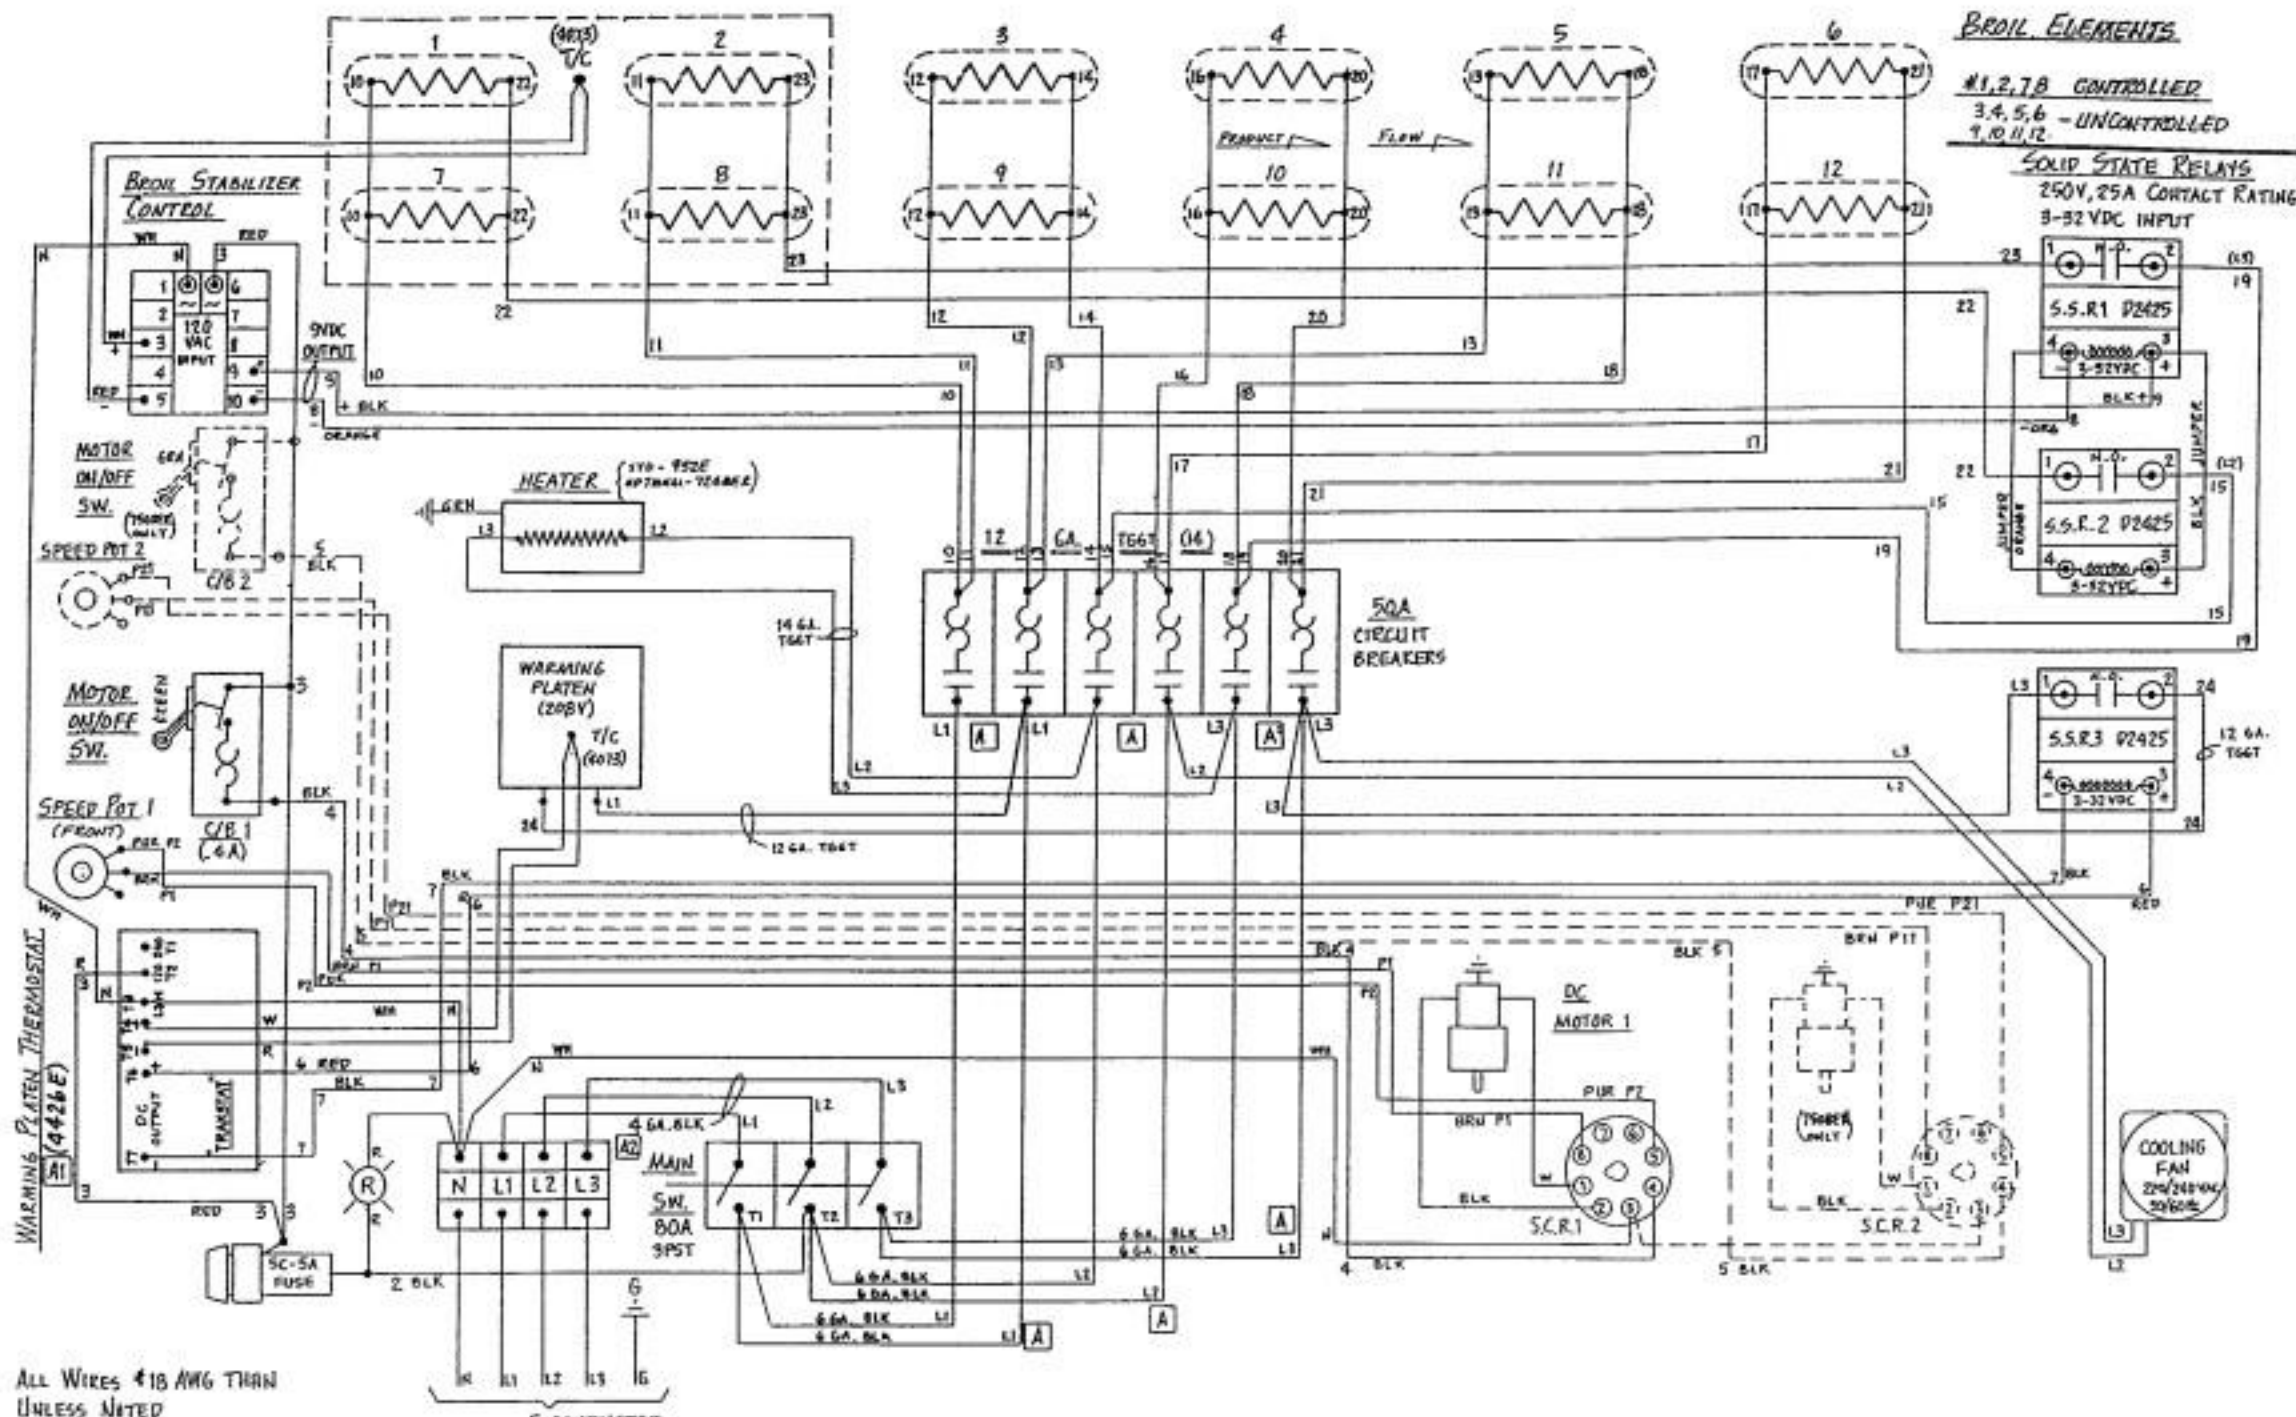
D	NEW PLATEN THERMOSTAT. WAS PH 407H-P240C	11-7-95	DZ
C	CHANGE PLATEN ATC, MAIN SW., DELETED CONTACTOR, ADD 2ND SCR. WAS: 1 4403PC 2 4059 3 4067	5-10-95	DZ
B	RE-LABEL CONTACTOR FOR U.L.	9-16-94	DZ
A	RE-DESIGN WAS: (6) ELEMENTS, (1) ATC, (1) SSR, (1) T/C	7-14-93	DZ

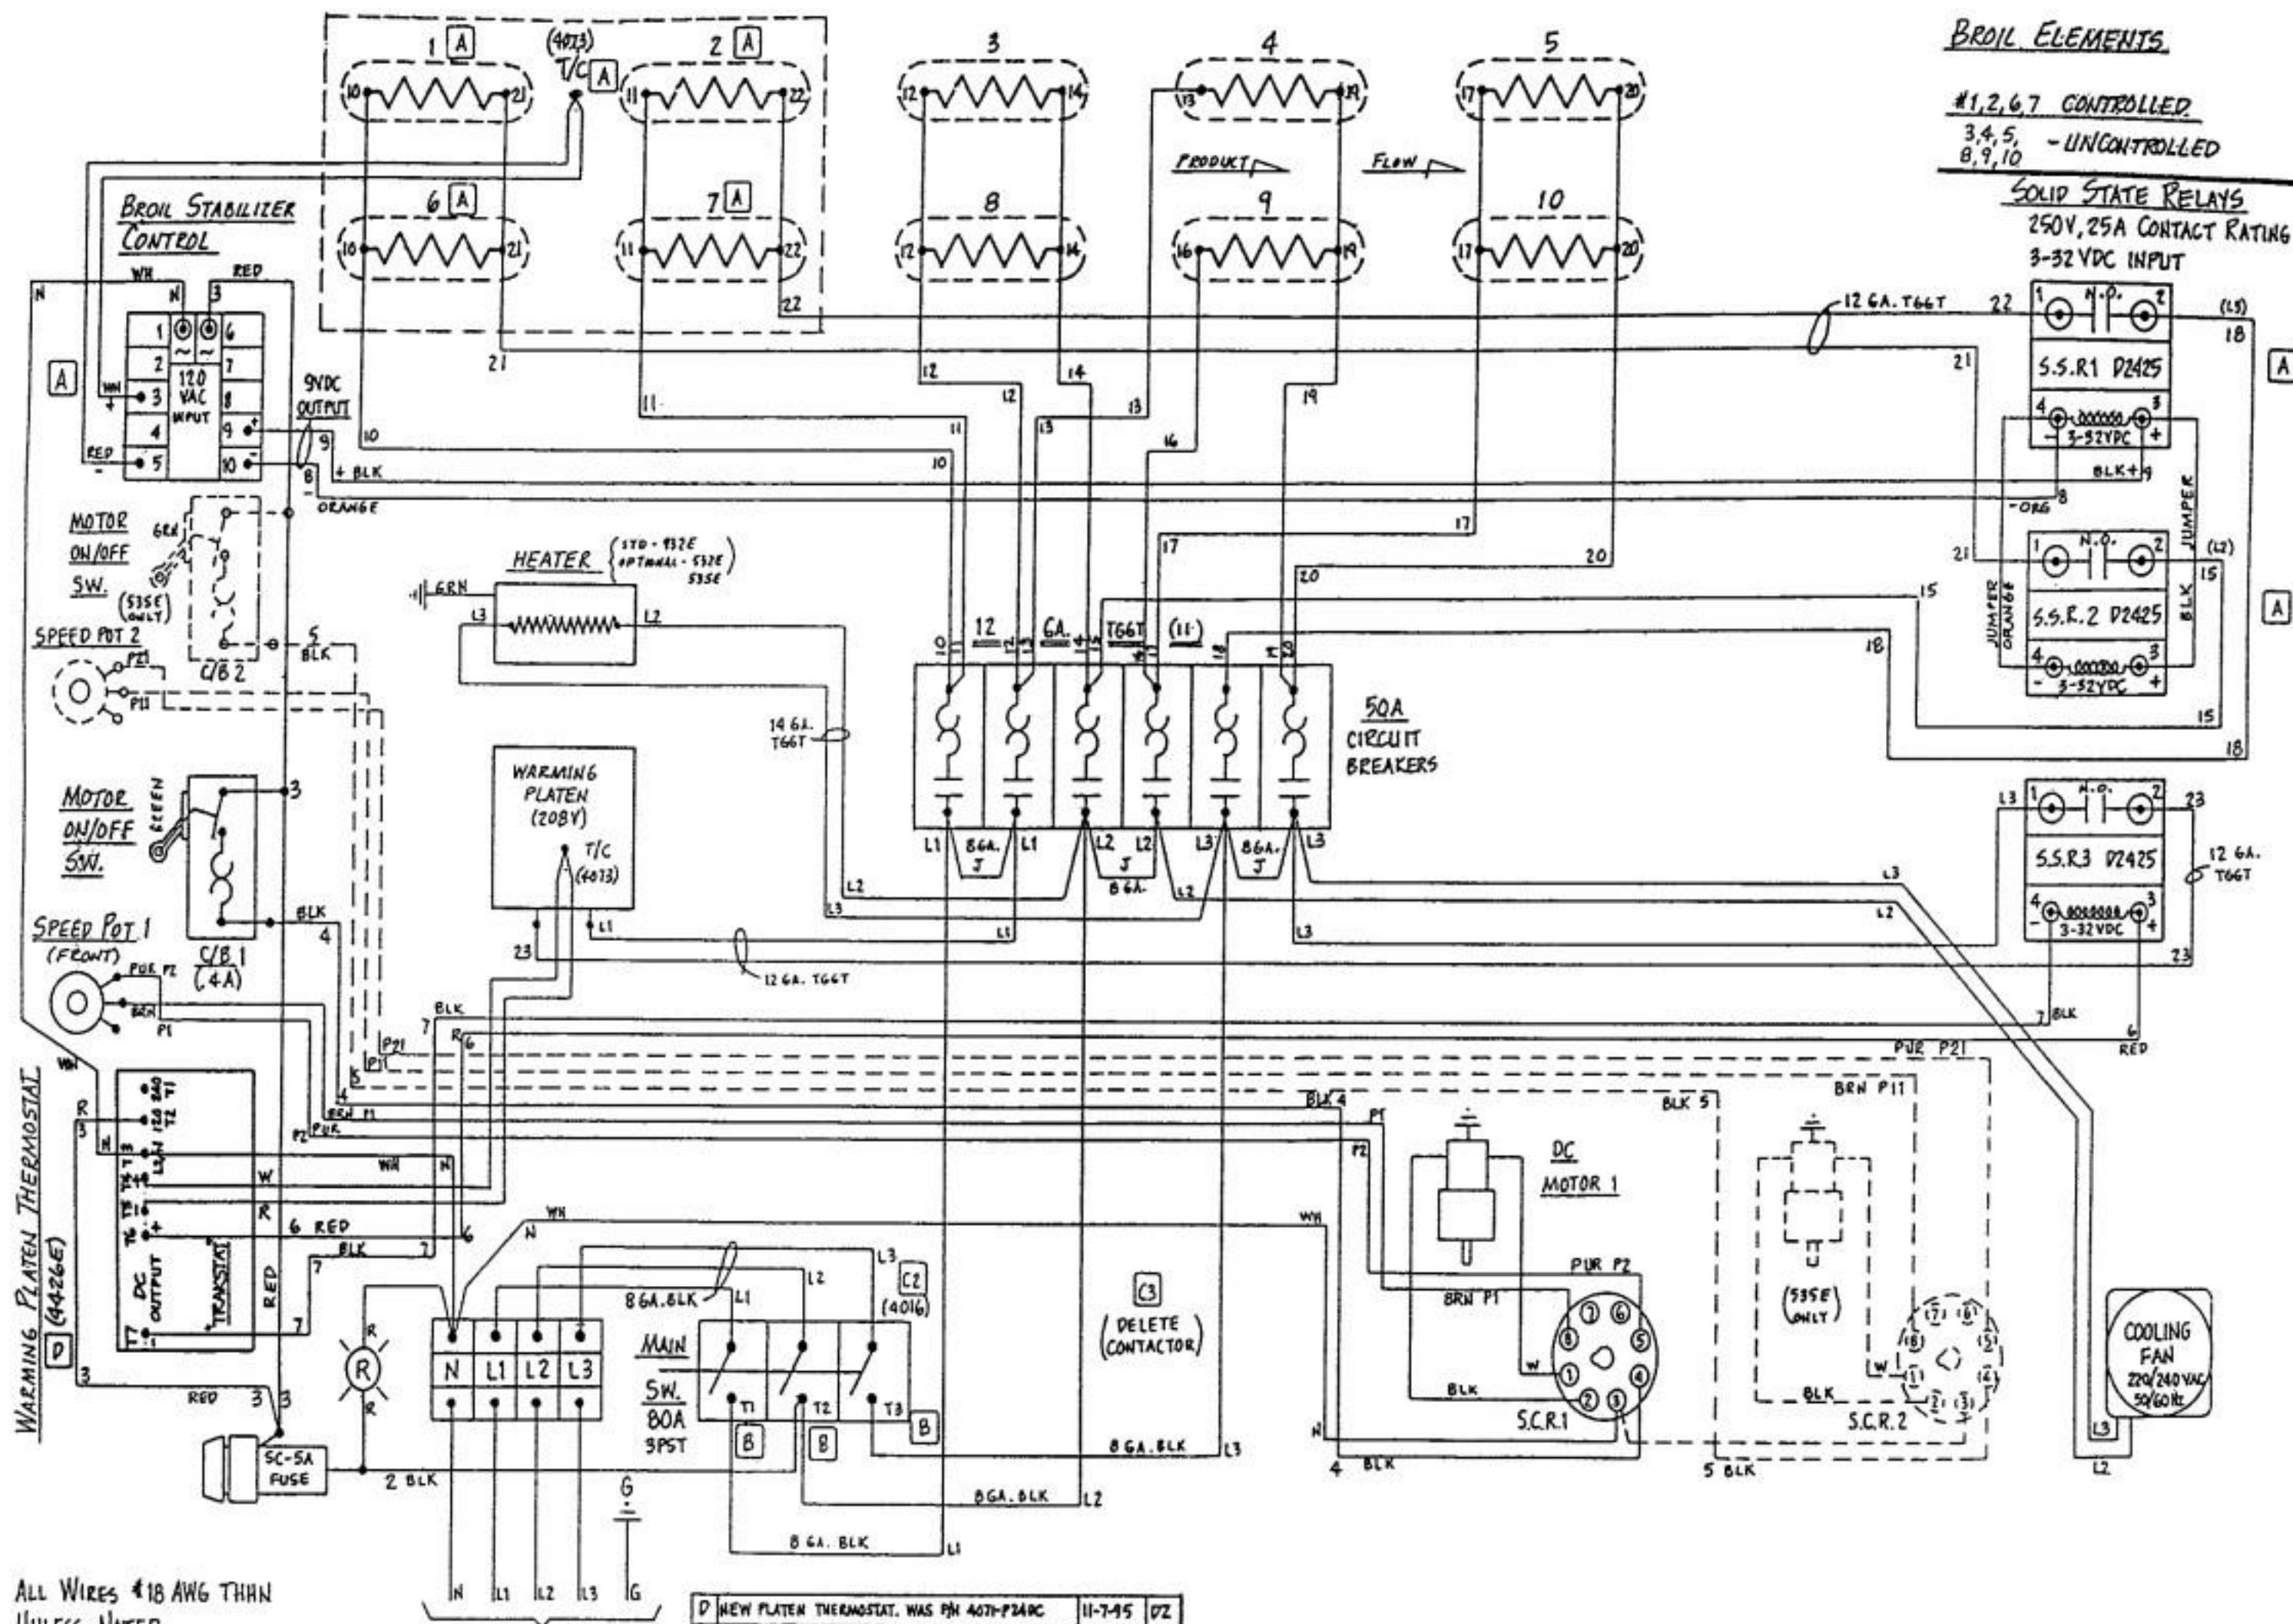
C	NEW PLATEN THERMOSTAT. WAS 4071-P24DC	11-7-95	DZ
B	OMIT (1) C/B, ADD (1) "N" BLOCK	6-20-95	DZ
A	MODIFY "NEUTRAL" CIRCUITS FOR C.E. APPL., CHANGE MAIN SW., DELETE CONTACTOR WAS: ① 4403-DC ② 4059 ③ 4067		5-10-95 DZ
